C0960-006
November 18, 2020

Re: **Site Review Permit & Conditional Use Permit for Parking Applications
Proposed Multi-Family Development, 105 Bartlett Street, Portsmouth, NH**

The enclosed revised plans and supplemental materials have been provided to address comments received from the Technical Advisory Committee (TAC) in correspondence dated June 1, 2020 and at their meeting held on June 2, 2020.

City of Portsmouth TAC, June 02, 2020:			
	TAC Comment	Applicant Response	Sheet
TAC Comments from 6/1 Correspondence:			
1	Driveway corner radius at Bartlett should be enlarged to provide easier access and egress. <i>(It does not appear modifications were made to address this)</i>	Driveway corner radius for right turns onto Bartlett Street has been increased from a 15-foot radius to a 25-foot radius.	C-102.1
2	Third party peer review of updated traffic generation memo shall be completed prior to Planning Board review.	Confirmed. Peer review memo has been completed by TEC. An updated Trip Generation Memo prepared by Stephan G. Pernaw & Company is also included with this submission.	N/A
3	Applicant is responsible for final design, construction, and permitting of the greenway trail along

UTILITIES PLAN

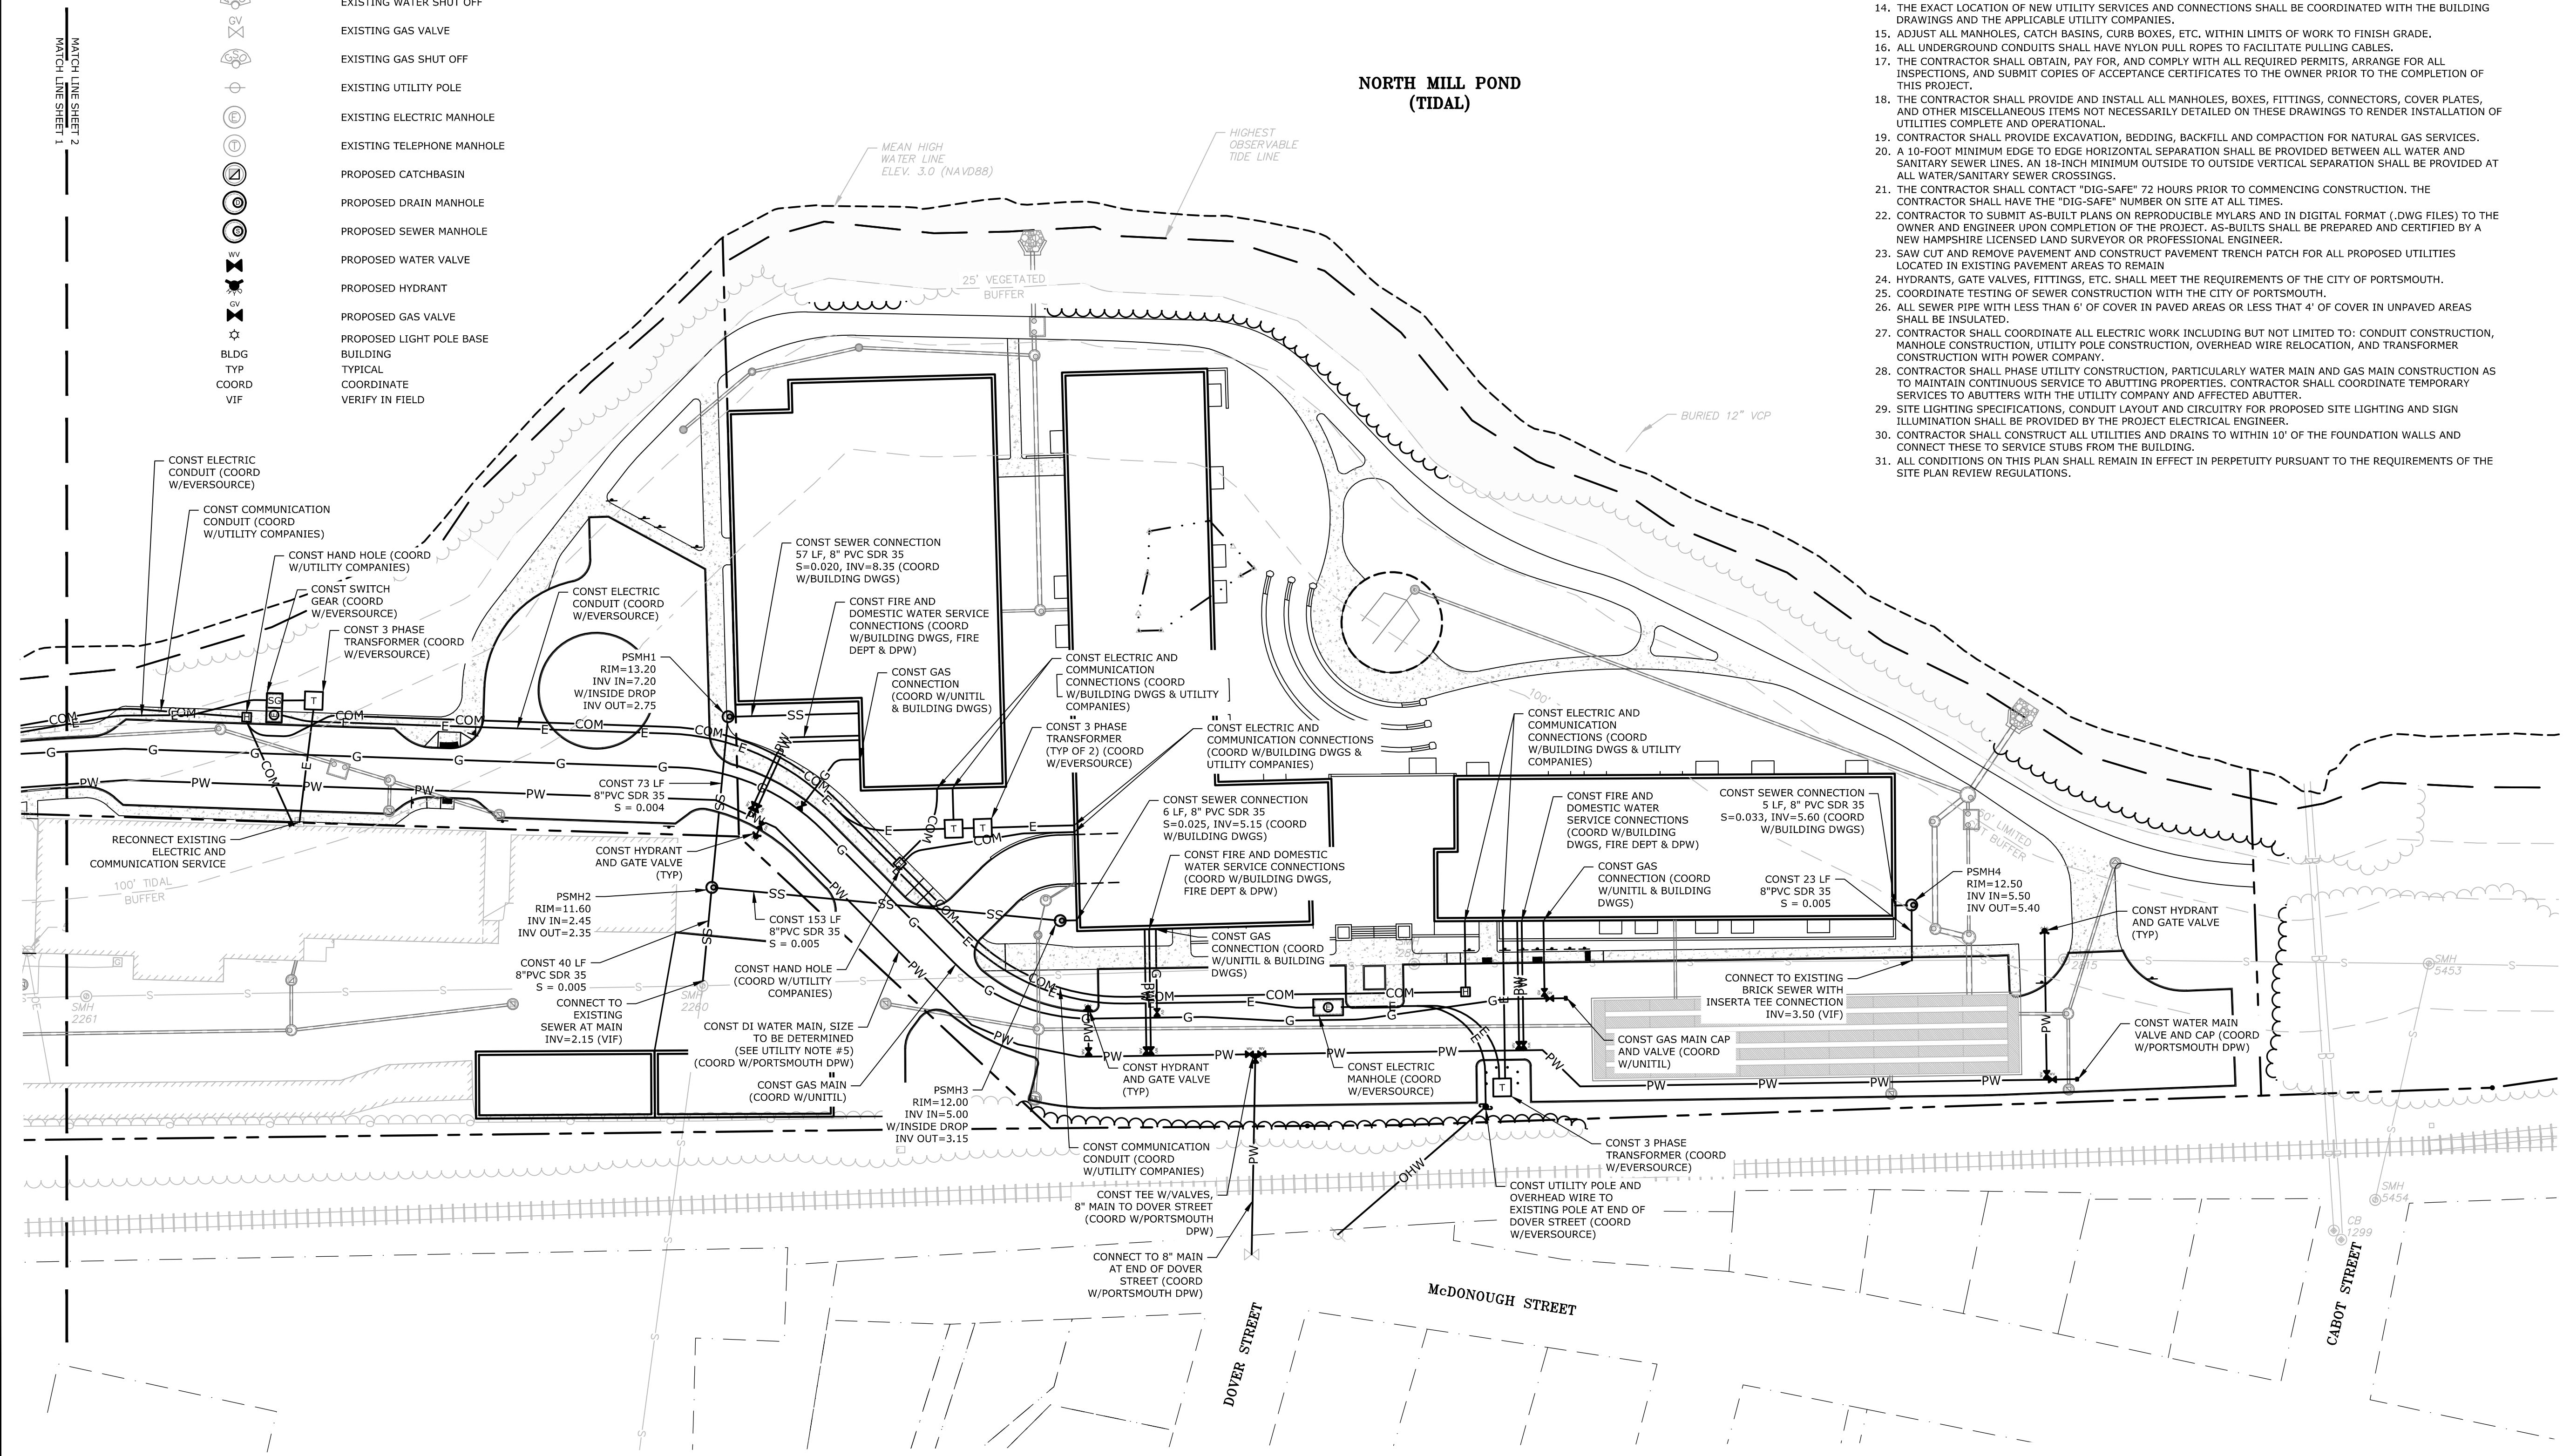
16	Designed to be useable including snow removal. Grade and ability to support fire truck and outriggers for a width of 14' minimum in rear of building	A detail has been added to show the minimum cross section of the community space trail which includes a 10' minimum width and a full depth gravel width of 14' to support a fire truck and outriggers. The path has also been designed to be wider at the building corners to allow for the fire truck turning to be within the paved path surface.	C-102.2 & C-502
17	Add proper signage for fire lane around rear of building	Fire lane signage has been added to the fire lane access.	C-102.2
18	Turning templates are too tight at turnaround.	Turning templates have been revised for the update site layout.	
19	Move Jellyfish 4 closer to the path for better maintenance access	Jellyfish 4 has been moved closer to the path for better maintenance access	C-103.2
20	Move fire hydrant at the end of Building A to the opposite side of the fire access to remove conflict with the proposed drainage. End of the main should be a tee to the hydrant, followed by a valve, 10ft of pipe and then the cap. Fire would prefer to keep the hydrant on the building side of the turnaround so the turn around is not blocked by a hose running across the access.	The revisions to the drainage and utilities plans have eliminated the conflict between the water line and the drainage lines and structures.	C-104.2

MOUNTABLE VERTICAL GRANITE CURB
NO SCALE

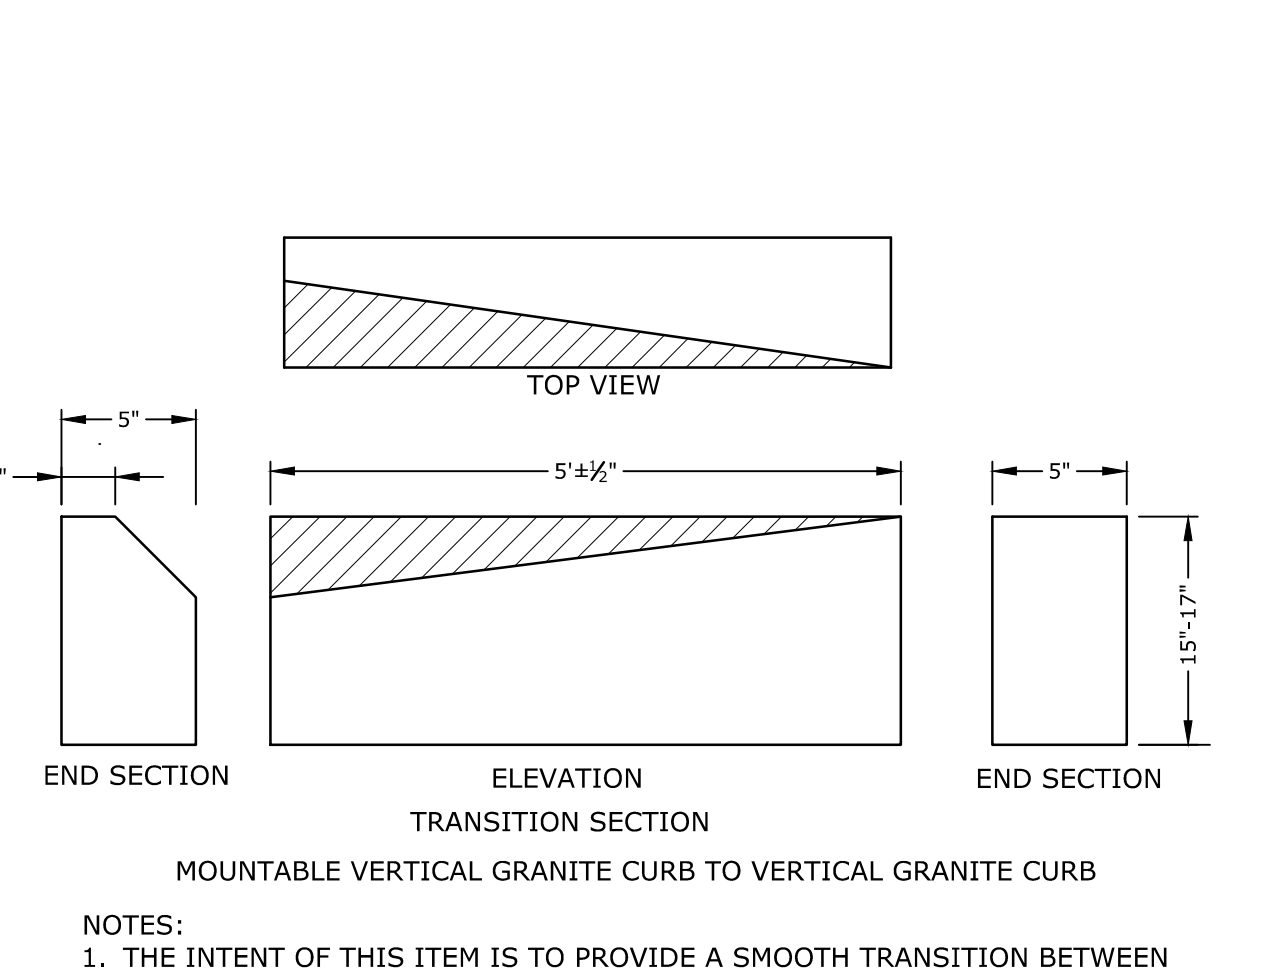
13	A detail should be provided for the mountable vertical curb proposed for fire access to the waterfront side of the buildings	A detail has been added for the mountable vertical curb and curb transition proposed for fire lane access to the waterfront side of the buildings	C-502
14	Visitor parking areas should be shown.	Visitor parking areas have been added to the site plan.	C-102.2
15	The no-parking / turn-around area at the end of the surface parking lot should be reduced to only include the driveway aisle and a single space furthest from the waterfront.	The no-parking / turn-around area at the end of the surface parking lot has been reduced to only include the driveway aisle and a single space furthest from the waterfront. The length of the parking area has also been reduced to pull all of the parking spaces out of the 100' tidal buffer zone.	C-102 & C-102.2
Additional Comments from 6/2 TAC Meeting:

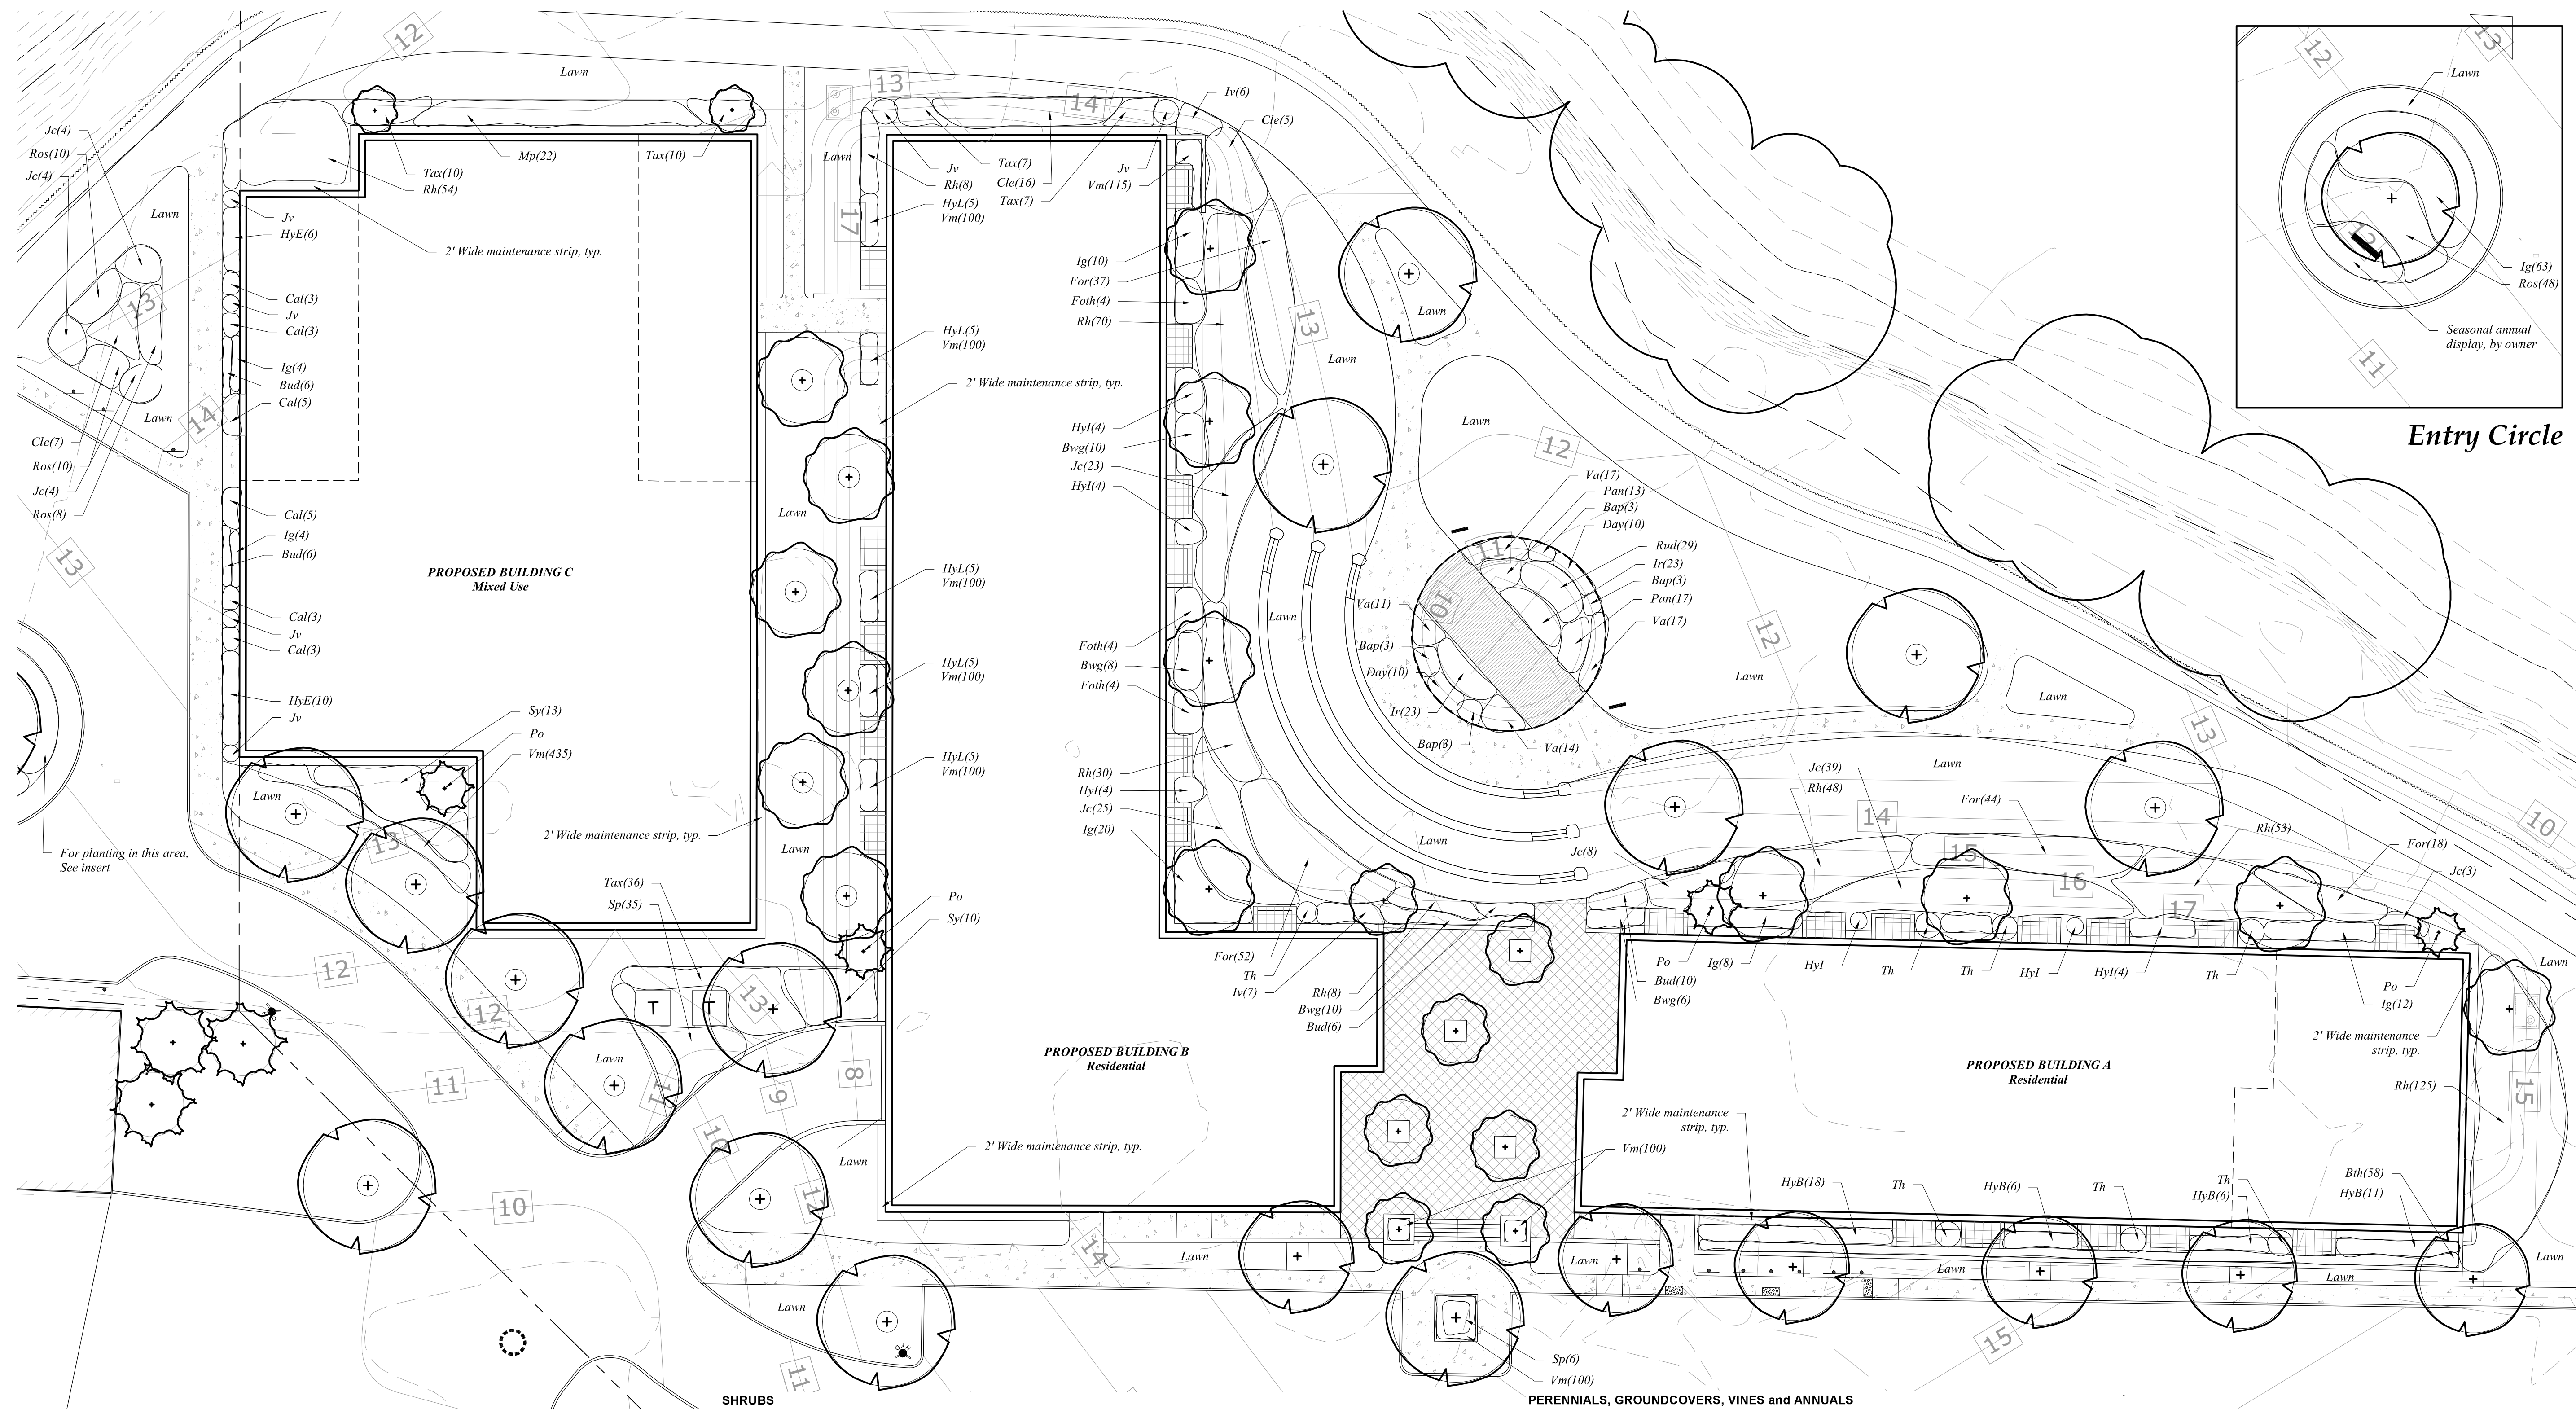
21	Add more detail landscape plan	More detailed landscape plans are included.	L-1
